**CITY OF ROCKVILLE HISTORIC DISTRICT COMMISSION  
STAFF REPORT**

**October 2, 2003  
MEETING NO. 11-03**

**APPLICATION:** HDC2003-00266

**APPLICANT/  
OWNER:** Andrew D. Sellman  
411 West Montgomery  
Avenue  
Rockville, MD 20850

## ANDREW SELLMAN

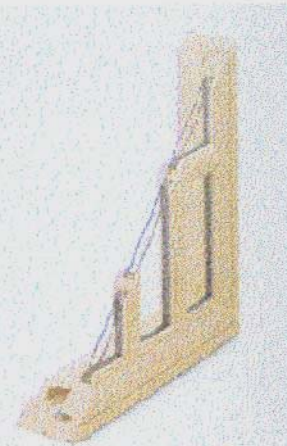
**City Staff recommends approval. Former owners converted this house to two apartment units and the original kitchen became a dining room and passage to the 1950s kitchen in the rear addition. The 1950 kitchen is not efficient and the owners want to restore the original floor plan. Consistent with pre air-conditioned houses, the 13X15 foot original kitchen has maximum ventilation openings. The existing two windows on the east wall are 12" from the floor, which precludes base cabinets and utilities. The replacement windows will be Marvin, true divided light double hung 6/1 windows, but sized and positioned to allow installation of base cabinets and utilities to make a workable kitchen. The applicant has selected a window that matches the original windows in material and design, and is planning to reuse the original windows.**

The house has a window hierarchy consisting of long 6/1 windows on the first story and shorter 6/1 windows on the second story. The windows have plain surrounds with a protruding drip cap and sill. The east façade is not a prominent one, the materials and design are consistent with the house, and the proposed improvement presents the least impact to the structure necessary to make a functional 2003 kitchen.

**STAFF RECOMMENDATION:** Staff recommends approval for replacement of two windows on the east façade of 411 West Montgomery Avenue with Marvin 6/1 wood double hung windows with integral muntins (true divided lights) with the condition that the original windows are to be preserved and used for future replacement and repairs.
